Access Compliance Report

Public Rights-of-Way

Intersection ID: 6611	Main Street: N_TRYON_ST	Cross Street: W_ROCKY_RIVER_RD	Location: E
ADA ID: AA7BE144751B	Ramp Type: BlendTrans1	Initial Pass/Fail: Pass	Overall Compliance: No
		Severity Score: 0

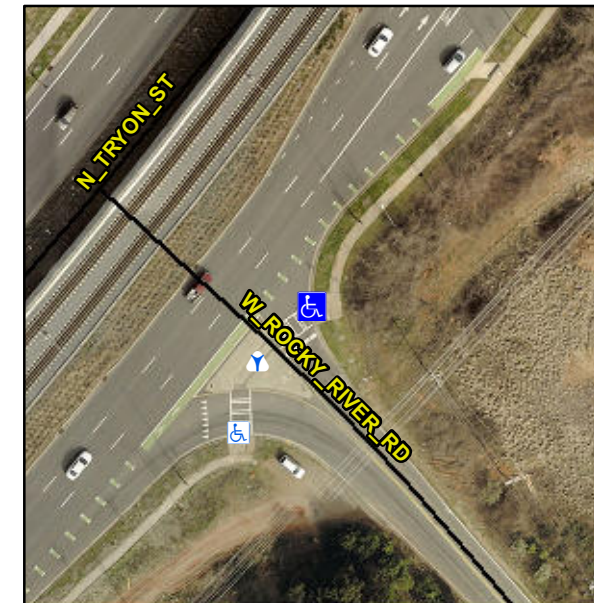
Not Found, R305.2

N/A	Ramp inside XWalk1?	N/A	Yes	Ramp inside XWalk2?	Yes
	Road Slope (%)	0.0		Clear Space?	Yes
	Road X Slope (%)	0.0	N/A	Clear Space to XWalk (in)	N/A
Yes	Any Obstructions?	No	Yes	Storm Grate/Utility Hazard?	No
	Obstruction Type			Storm Grate/Utility Type	
		N/A			N/A
			Yes	Surface Condition? (G/P)	Good
			No	Curb Slope (%)	16.2

Remove & Replace Curb Ramp With Two New Directional Ramps or Equivalent.
